CITY OF ALBUQUERQUE

PLANNING DEPARTMENT - Development Review Services

RE: O'Niell's Addition & Remodel, 4310 Central Ave SE Request For Permanent Certification of Occupancy Engineer's Stamp Date 3-27-2014 (K17D100)

GRADING AND DRAINAGE PLAN

2041 CG-101.dwg

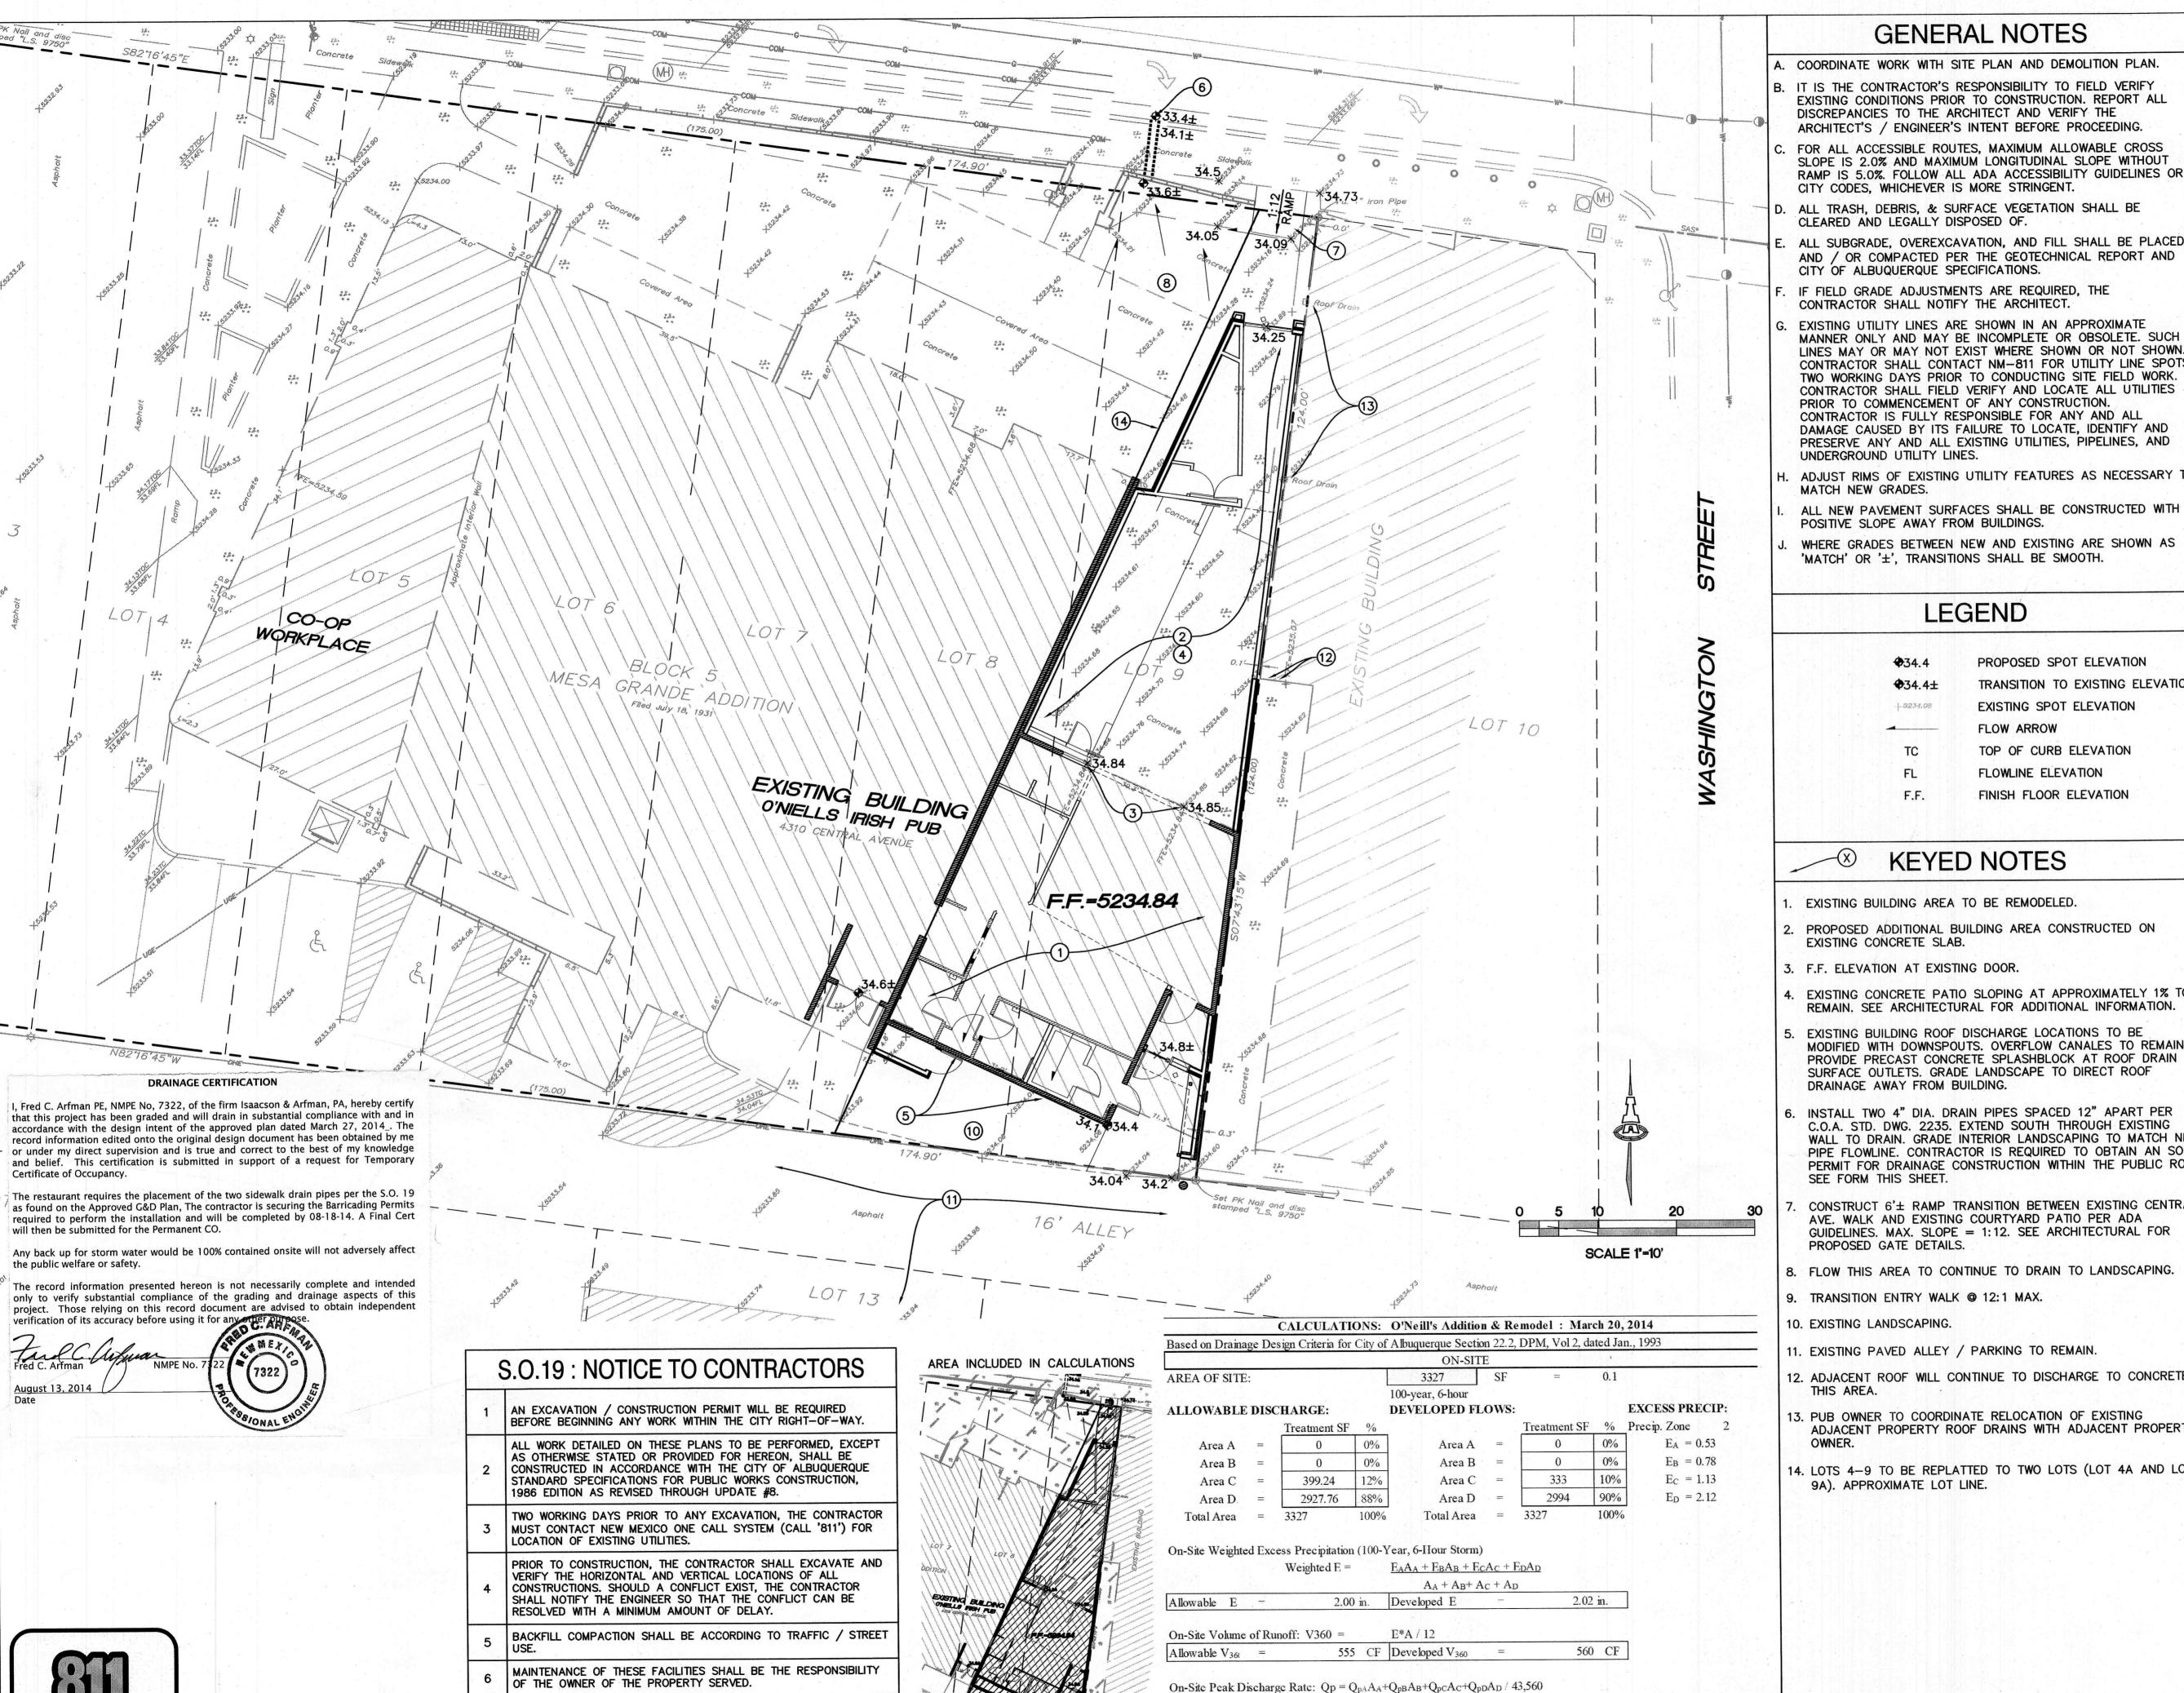
The two PVC curb penetrations at O'Niells Pub are a pass document K17-D100 if you need any more let me know.
